CITY of CALABASAS

PLANNING COMMISSION AGENDA REPORT
SEPTEMBER 17, 2020

FILE NO.: 180000265

PROPOSAL: Request for a Site Plan Review, Oak Tree Permit, and Scenic Corridor Permit to construct a 2,121 square-foot one-story single-family residence with an attached two-car garage. The proposed project includes a request for an Oak Tree Permit to encroach within the protected zone of four (4) oak trees and the removal of four (4) non-heritage oak trees, in order to construct the house and necessary site improvements. The subject site is located at 24226 Dry Canyon Cold Creek Rd (APN: 4455-047-014), within the Hillside Mountainous (HM) zoning district and the Scenic Corridor (SC) overlay zone.

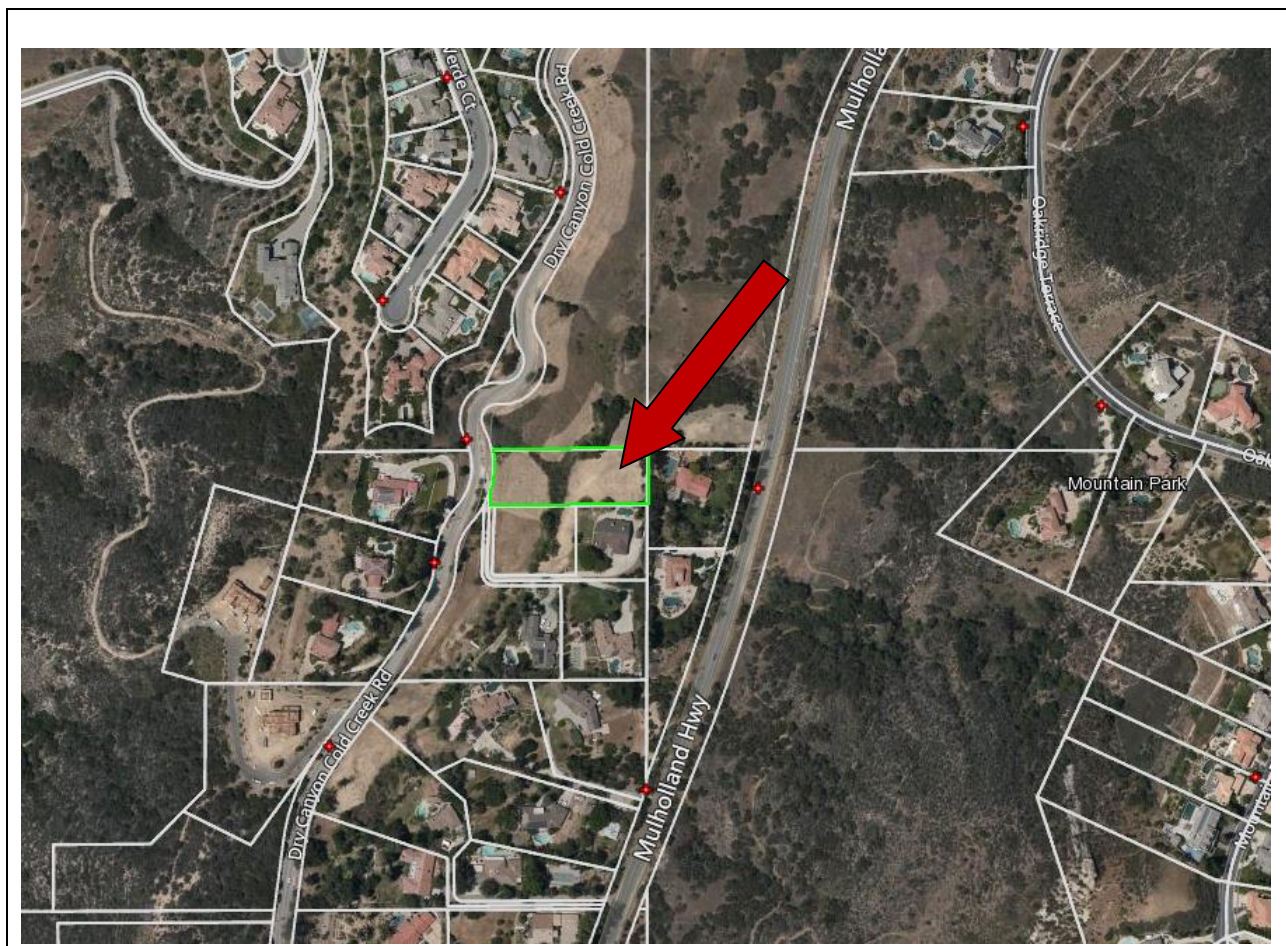
October 26, 2018 The applicant provided the Panel with color renderings and colors and materials sample. The Panel noted that while there are no modern homes in this area, they are supportive of a good modern design at this location. However, the panel stated that some of the elevations are lacking articulation, and asked the applicant to incorporate additional modern elements into the design. The Panel suggested that the rear (east) elevation should be enhanced with the same roof overhang as the front (west) elevation, and the south elevation should incorporate the same wood siding as the front elevation. The Panel suggested that the design incorporate higher roof plates at different locations and avoid one flat roof plane. The Panel noted that the windows are not symmetrical, and suggested that windows are re-arranged for better symmetry. The Panel continued the item to a future meeting.

January 25, 2019 Staff recapped comments from the last ARP meeting the project was reviewed at. Project applicants, Zalman Nemtzov, Steven Fernandez and Marsha Cohen, were present representing the project, presented the revised project, and answered questions from the Panel. The Panel recommended the proposed wood siding wrap around the rear elevation of the garage. The Panel also presented a concern about the color of the TPO roof (white) proposed to comply with Building Code requirements. The Panel recommended use of a color other than white for all exposed roofing material. Suggestions were made by Panelists to consider either use of solar panels or a planted roof to aid in hiding the brightly colored cool roof. Furthermore, the Panel recommended, in lieu of recessed gutters and downspouts, to use a roof drain and overflow device which will be hidden behind the parapet and the downspout will be a pipe from the drain running down through the exterior wall and outletting at the bottom floor, eliminating overflow scuppers. Lastly, the Panel recommended expanding the volume of the entry into the house. All recommended changes (including if solar panels are proposed) shall be reviewed by Panelist Mugerdechian-Armen prior to going to the Planning commission. With the described recommendations, the Panel recommended approval of the design.
